Howdy! Please accept this transmittal as written request for CoM consideration and direction to correct the proposed driveway access to Suncrest and Ralph Ritchie. I am presenting this request in my capacity as Developer representative to Cottonwood Holdings Ltd, (CHL) the adjoining property owner immediately to the south of the subject property as referenced in Case 2022-P-1476-CU.

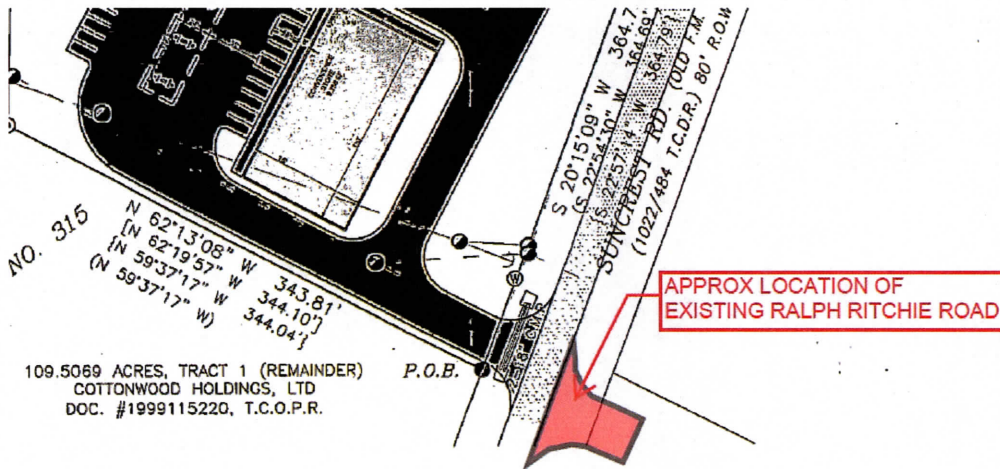
It is our concern that the Suncrest driveway location as proposed on the attached application creates an unsafe opposing offset from Ralph Ritchie. (See below with approximate location of Ralph Ritchie.)

Further the driveway as proposed compromises CHLs site development and driveway access along Suncrest due to required design speed offset between driveways if CHL is unable to obtain access to the Applicant's proposed driveway to Suncrest.

It is the request of CHL, that the Applicant should be required to coordinate a Joint Driveway Access with CHL (that CHL agrees to accommodate) for the construction of a shared driveway that has the proper direct opposing offset from Ralph Ritchie at Suncrest. This joint access can then be used by both the Applicant and CHL for the future development and betterment of their sites and assure the proper geometric turning movements along Suncrest.
